Proposed Changes to Final Lead Commissioner Report – 2013 Integrated Energy Policy Report

**Summary of Proposed Changes to
2013 Integrated Energy Policy Report
Final Lead Commissioner Report**

**For Consideration at the January 15, 2014
California Energy Commission Business Meeting**

Figure 3: IOU Demand Response 2008-2013*

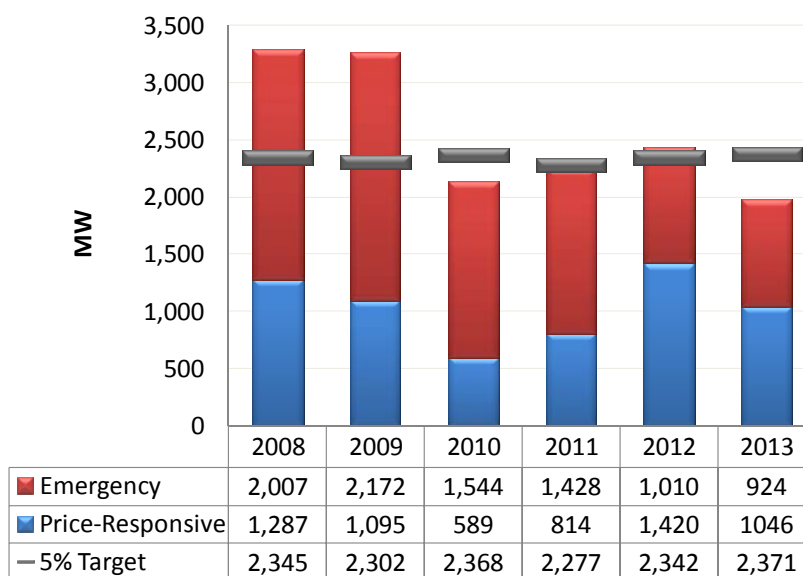
Chapter 2 (Demand Response), page 42, Figure 3:

Figure 38: California Energy Demand Final 2013 Forecast and Extrapolation to 2035, RPS Eligible Retail Sales, GWh

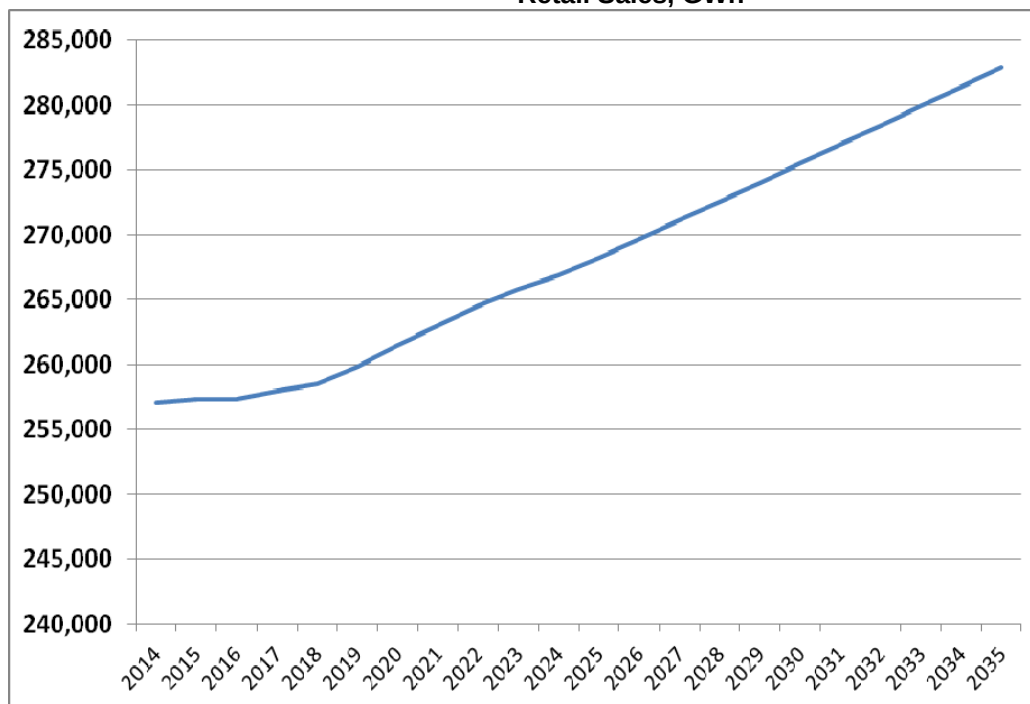
Chapter 9 (Climate Change) page 244, revision to Figure 38
